SUBJECT: Defense Environmental Restoration Program – Formerly Used Defense Sites (DERP-FUDS) Record of Decision for Sanak Aircraft Warning Service (AWS) Station, FUDS Project No. F10AK0204-02, Sanak Island, Alaska

RECORD OF DECISION

SANAK ISLAND AIRCRAFT WARNING SERVICE STATION

FUDS No. F10AK0204-02

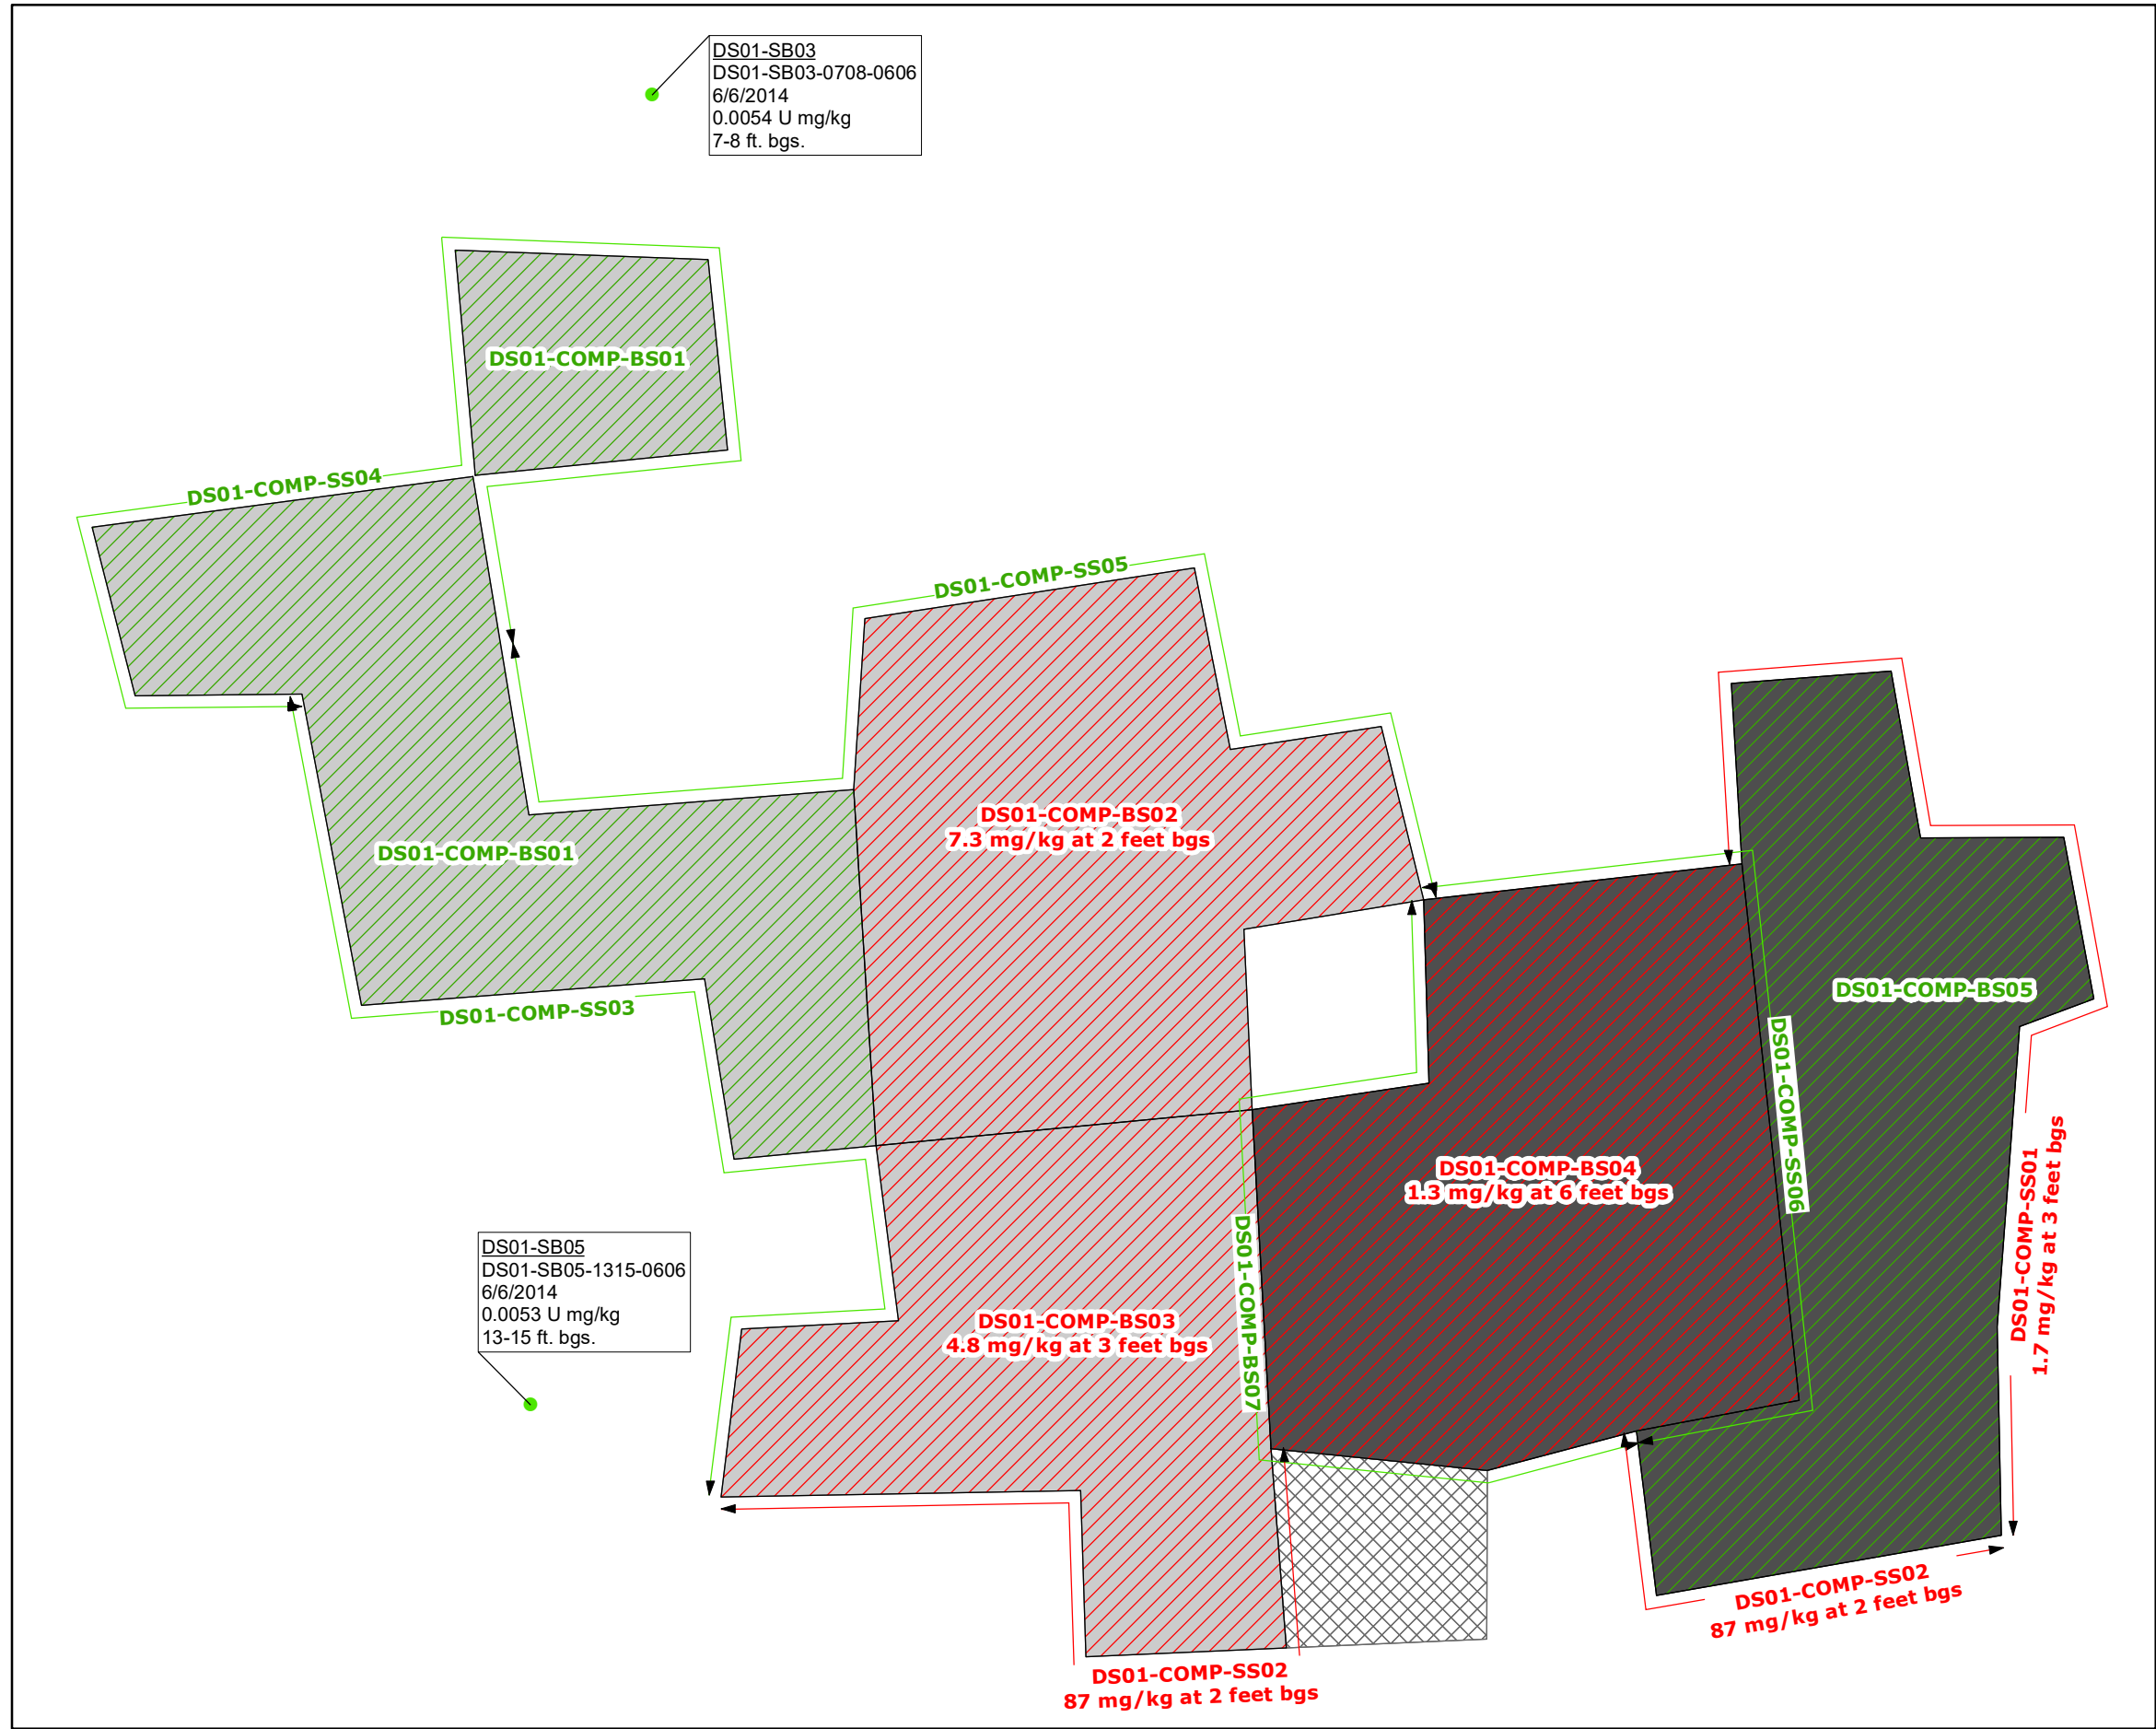
4.	Figure A-3	The table of Laboratory Analytical samples does not match the samples in this figure. Please revise to the correct samples.		The figure will be revised so the table matches the samples shown. The sample table will be removed from Figure A-3. This was coordinated with Ms. Iler-Galau at ADEC on 3/27/25 and determined to be acceptable.	A Pending Backcheck
End of Comments
